Access Compliance Report Public Rights-of-Way (Curb Ramps)

Main Street: MCGWIRE_RD Cross Street: O_NEILL_DR Location: NW

ADA ID: RPRK211025131440 Ramp Type: Type 1 - Perpendicular Diagonal Initial Pass/Fail: Pass Overall Compliance: No Severity Score: 26

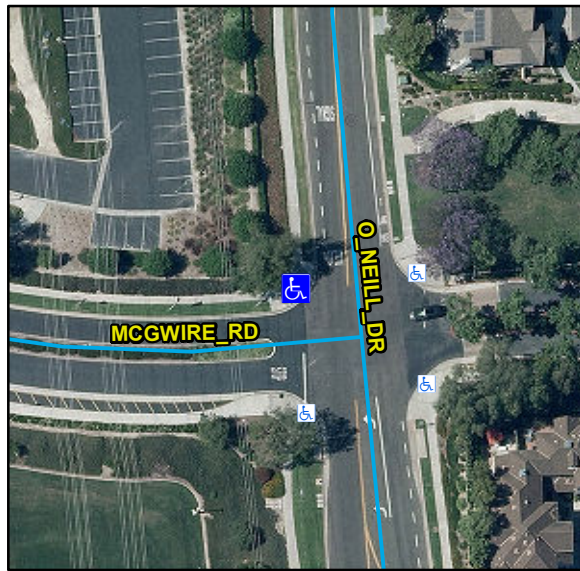
N/A	Ramp Inside Crosswalk 1	N/A	Yes	Ramp Inside Crosswalk 2	No
	Crossing 1 Slope (%)	2.7		Crossing 2 Slope (%)	0.8
	Crossing 1 Cross Slope (%)	3.9		Crossing 2 Cross Slope (%)	0.6
Yes	Gutter Ponding	No	No	Curb Slope	9.7
Yes	Gutter Lip Height (in)	0		Road Run Slope (%)	1.1
No	Gutter Run Slope (%)	9.2		Road Cross Slope (%)	5.7
Yes	Gutter Cross Slope (%)	0.4			
Yes	Overall Surface Condition: Acceptable		No	Perp Joint Present	No
	Cross Gutter Present?	No		Spandrel Present?	No
	Replace Cross Gutter?	N/A		Replace Spandrel?	N/A

Remove & Replace Curb Ramp With Two New Directional Ramps or Equivalent. Restripe Crosswalk. Remove & Replace Gutter.
